FIRE SAFETY INSPECTION REPORT

KNIT ASIA LTD
EAST NARSHINGAPUR, BURIPARA, EARPUR,
ASHULIA, DHAKA

ACC  **RD**
on Fire and Building Safety in Bangladesh

June 8, 2014

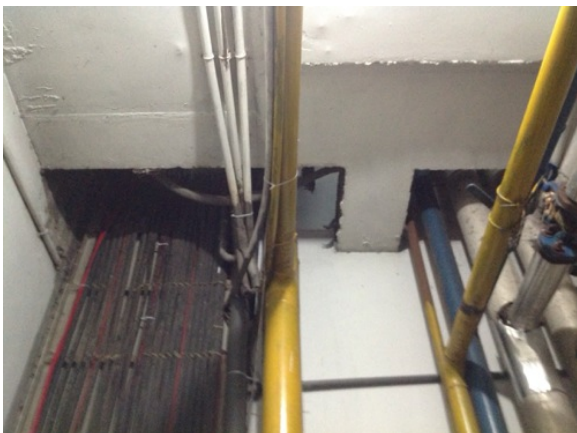
No.	Category	Finding	Recommendation	Remediation Timeframe
F-1	Fire Rated Construction	Areas used for storage on the ground floors warehouse is not separated by fire rated construction. These areas were found i the basement, ground floor, 4, and 5 floors.	<p>Provide dedicated storage rooms separated by minimum 1-hr fire-rated construction.</p> <p>Where separate storage rooms are not feasible, provide defined storage areas and limit the storage arrangement as follows:</p> <ul style="list-style-type: none"> - Maximum height of 2.4m and maximum area of 23m² - If sprinkler protected: maximum height of 3.66m and maximum area of 93m² <p>Separate areas of unenclosed combustible storage by a minimum clear distance of 3m.</p>	Within 3 months
